GM SERVICE AND PARTS OPERATIONS
DCS 2201
URGENT - DISTRIBUTE IMMEDIATELY

Subject: 08178A– Product Safety Bulletin
Automatic Transmission Shift Lever Shifts Out Of Park

Models: 2004 Cadillac SRX With Automatic Transmission

SUBJECT: Automatic Transmission Shift Lever Shifts Out of Park

2184264

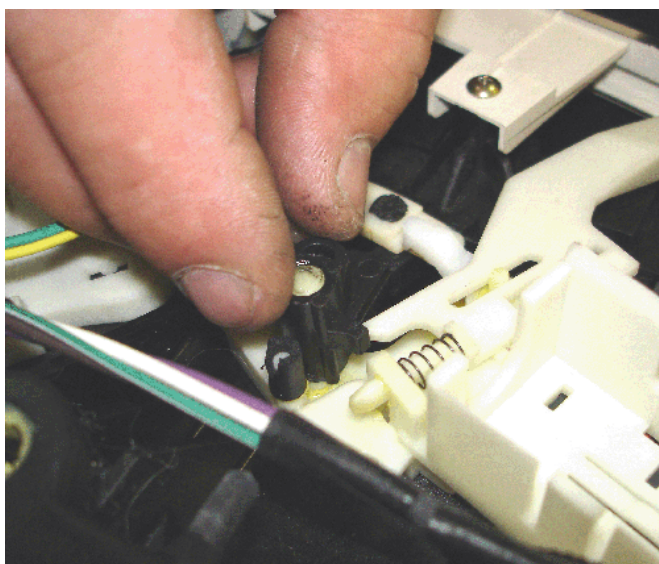
Caution: Do NOT attempt to pry the park override arm up to remove the pawl stopper. Do NOT attempt to lift the pawl stopper off of the pivot pin until the pawl stopper clears the park override arm.

4. Push down on the tip of the park override and rotate the pawl stopper counterclockwise until it clears the park override.
5. Lift the pawl stopper off of the pivot pin. Do not wipe the grease from the pivot pin.
6. Replace the pawl stopper with the new black pawl stopper from the kit.

2184249

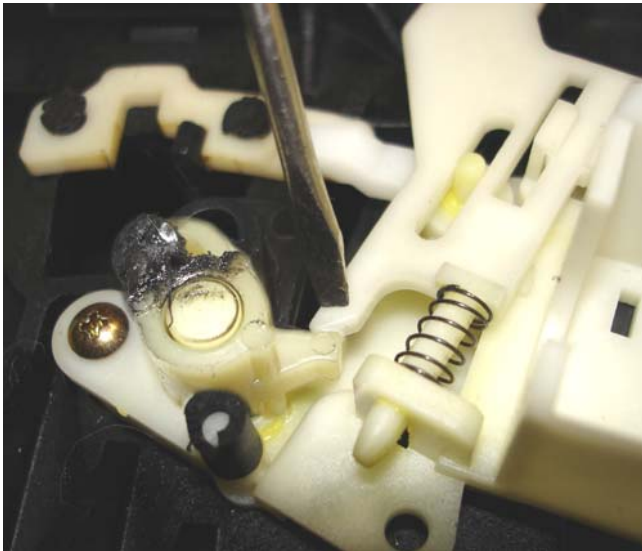
Notice: Do not loosen the screws (1) more than two turns. Do not remove the screws (1) retaining the BTSI solenoid cradle and pawl stopper assembly.

4. Loosen the two screws (1) retaining the BTSI solenoid cradle and pawl stopper assembly two (2) turns.

2184264

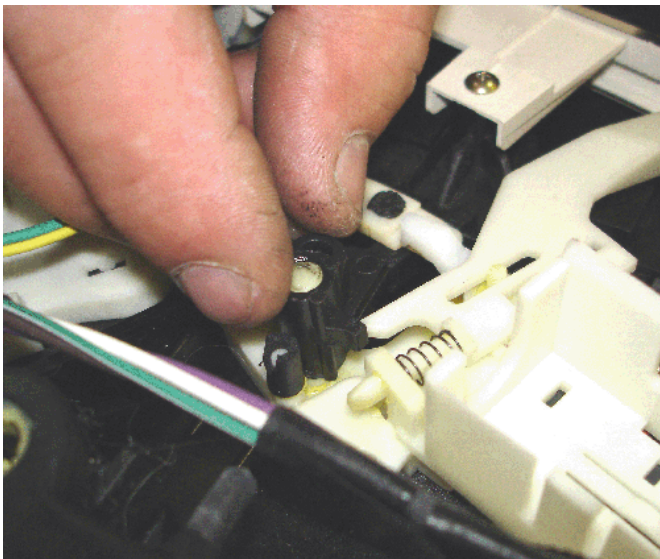
Caution: Do NOT attempt to pry the park override arm up to remove the pawl stopper. Do NOT attempt to lift the pawl stopper off of the pivot pin until the pawl stopper clears the park override arm.

5. Push down on the tip of the park override and rotate the pawl stopper counterclockwise while lifting the stopper to clear the rib that is part of the shifter base, until it clears the park override.
6. Lift the pawl stopper off of the pivot pin. Do not wipe the grease from the pivot pin.
7. Replace the pawl stopper with the new black pawl stopper from the kit.

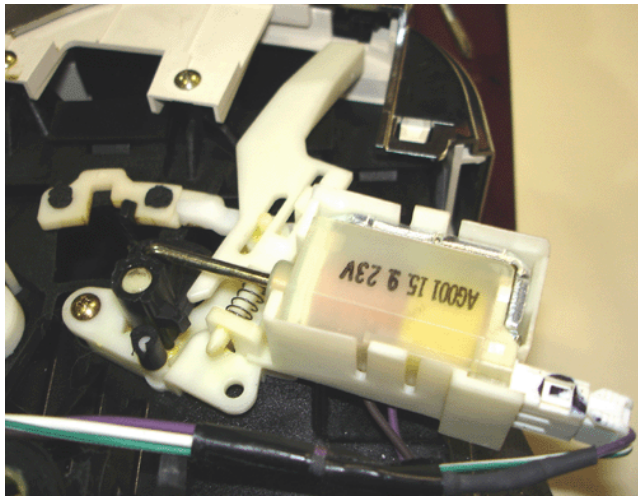
- 7.2. Push down on the tip of the park override and rotate the pawl stopper clockwise until it is in position.
8. Retighten the two screws retaining the BTSI solenoid cradle and pawl stopper assembly.

Tighten the two screws retaining the BTSI solenoid cradle and pawl stopper to 5 N·m (44 lb in).
